Office Action Summary	Application No. 10/573,703	Applicant(s) KRUG-KUSSIUS, KARL	
	Examiner WILLIAM MCCALISTER	Art Unit 3753

DETAILED ACTION

4,289,160

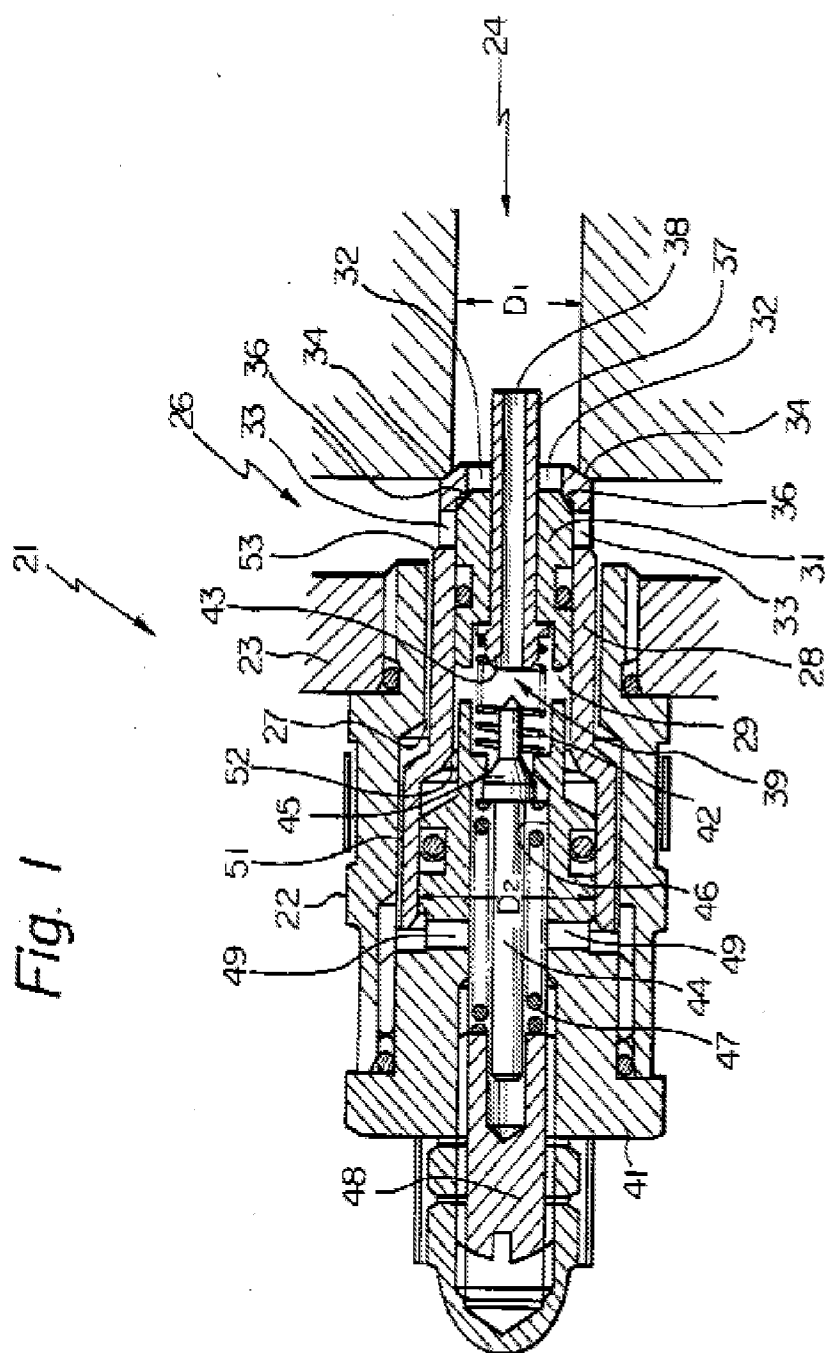
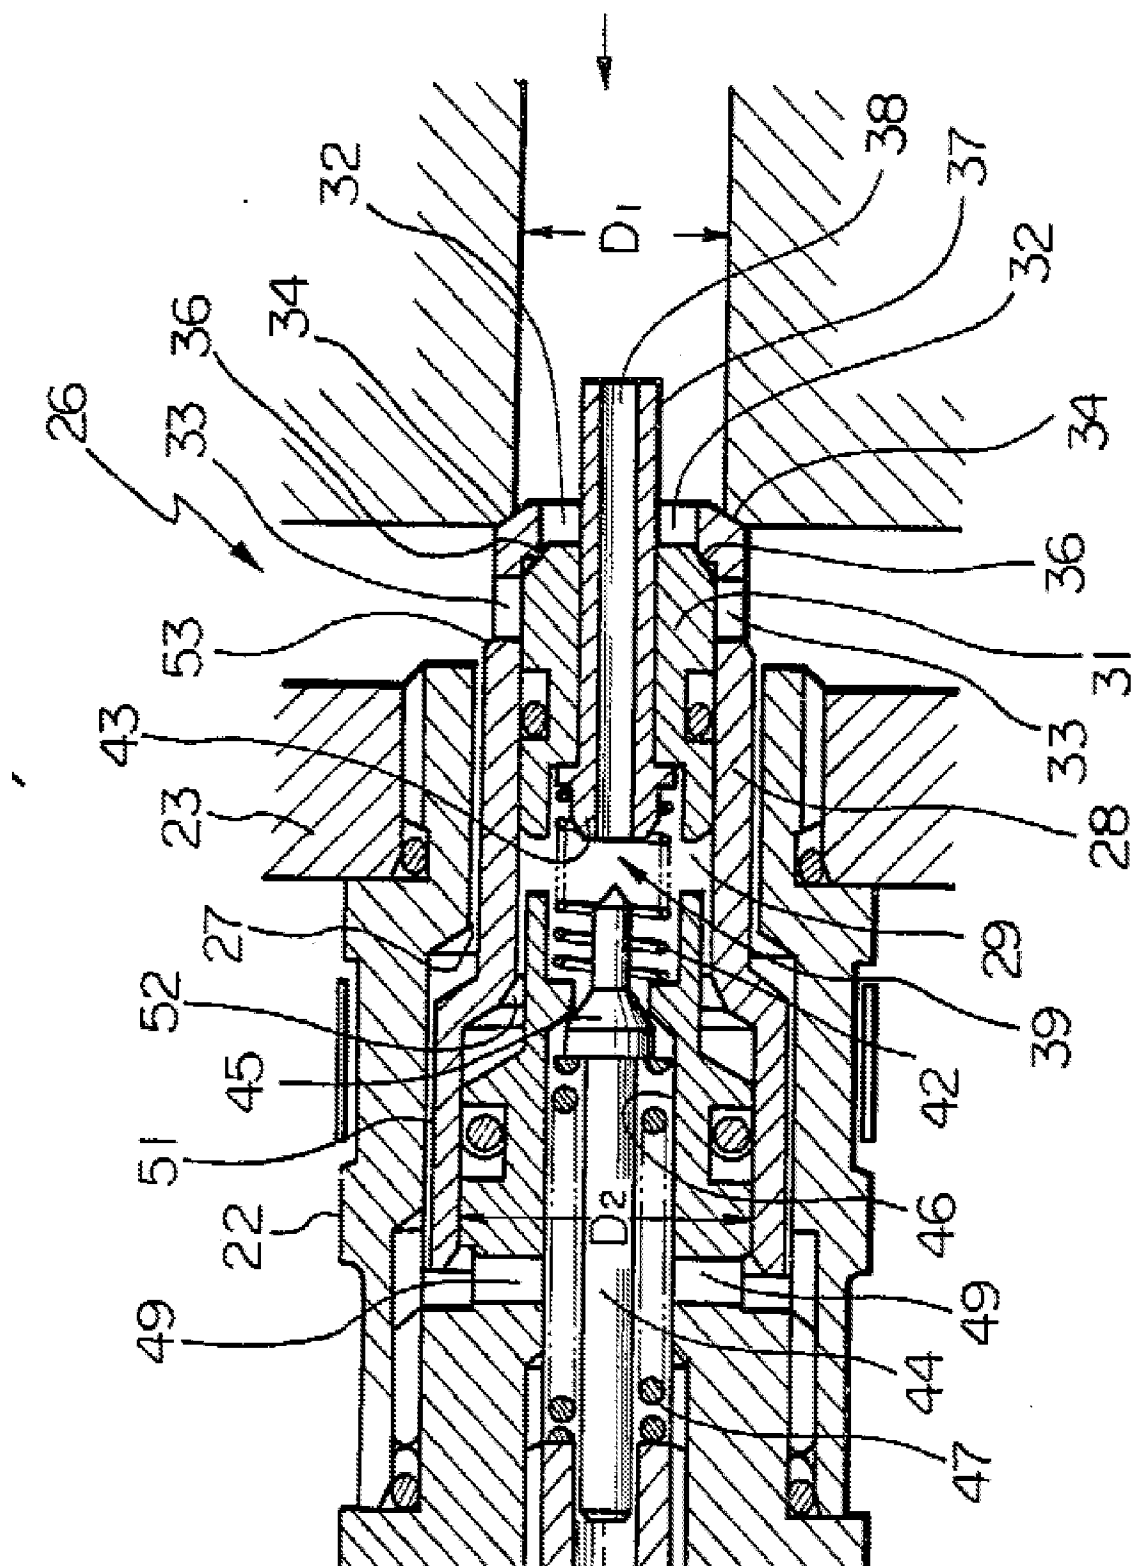
2. Claims 1 and 7 are rejected under 35 U.S.C. 102(b) as being anticipated by Kawasaki (US Patent 4,289,160).

With regard to claim 1, Kawasaki discloses a pilot-controlled pressure feed valve, comprising a piston (31) of a main stage whereby a connection between an input port (24) and an output port (26) may be controlled open, and the spring chamber (39) of which is adapted to be connected with the input port via a piston bore (38) and with a control oil drain (51) via a pilot control stage

(49), characterized by a throttle valve means (37, 43, 45) which throttles a control oil flow through the piston bore from the input port into the spring chamber in a closed position (broadest reasonable interpretation of “closed position” includes the position in which end 43 of element 37 is approaching element 45), and controls open a comparatively large cross-section of flow in the anti-cavitation function (that position illustrated in FIG 1) in the event of a control oil flow in the opposite direction (although the anti-cavitation function of Kawasaki is performed primarily by the movement of element 28, any void formed in inlet 24 would also be replenished by fluid from the spring chamber).

FIG. 1

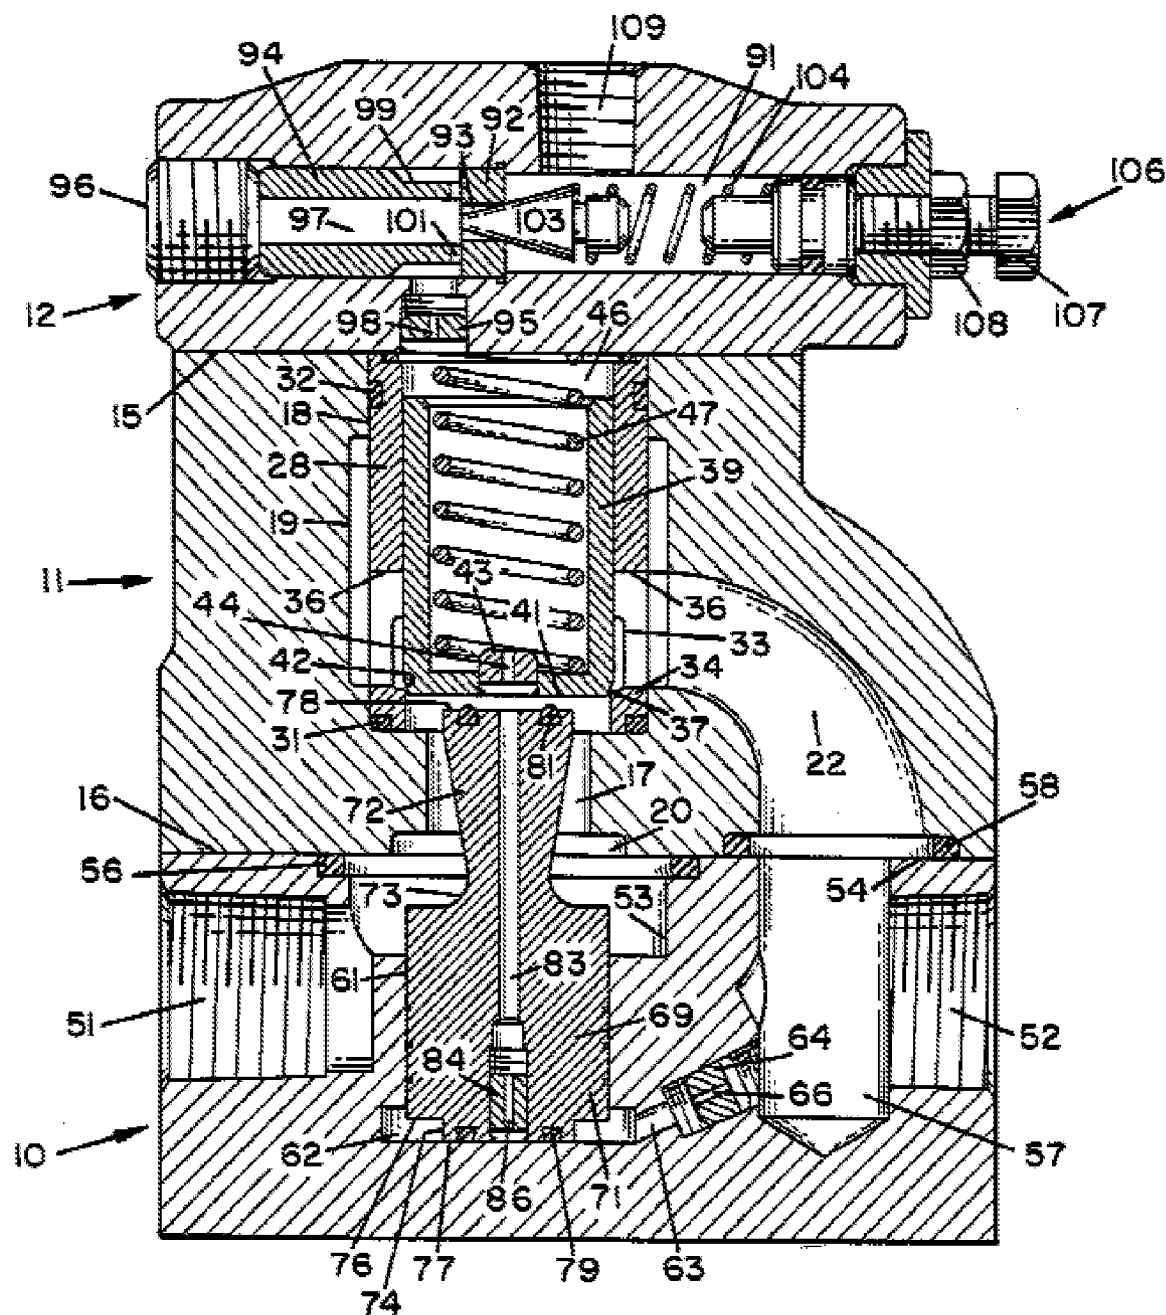
3. Claims 1, 2, 4, 6, 7, 10, and 12-16 are rejected under 35 U.S.C. 102(b) as being anticipated by Adams (US Patent 3,090,398).

With regard to claim 1, Adams discloses a pilot-controlled pressure feed valve, comprising a piston (39) of a main stage whereby a connection between an input port (52) and an output port (51) may be controlled open, and the spring chamber (46) of which is adapted to be connected with the input port via a piston bore (see opening in piston 39 to which plug 43 is attached) and with a control oil drain (109) via a pilot control stage (12), characterized by a throttle valve means (72) which throttles a control oil flow through the piston bore from the input port into the spring chamber in a closed position (see column 6 lines 33-46), and controls open a comparatively large cross-section of flow (not restricted by the size of bore 83) in the anti-cavitation function in the event of a control oil flow in the opposite direction (see column 5 lines 20-24 and lines 70-74).

With regard to claim 2, Adams discloses the throttle valve means to be a throttle check valve having a nozzle plate (78) which is penetrated by a nozzle bore (83) having a smaller diameter than the piston bore, and which is adapted to be taken with an end face thereof into contact with a nozzle plate seat (41), wherein the nozzle bore may be passed by in a condition where the nozzle plate is raised from the nozzle plate seat by a flow around said nozzle plate (during the anti-cavitation function of the analysis in claim 1, see column 5 lines 20-24 and lines 70-74).

With regard to claim 4, Adams discloses the nozzle plate to have at the circumference flattenings which delimit a cross-section of bypass flow (distal circumference of element 72 restricts flow through channel 17).

With regard to claims 6 and 10, Adams discloses the throttle check valve to be inserted into a valve chamber (that area generally surrounding elements 41 and 78) of the piston bore (18) into which a seat sleeve (41) forming the nozzle plate valve seat is inserted.
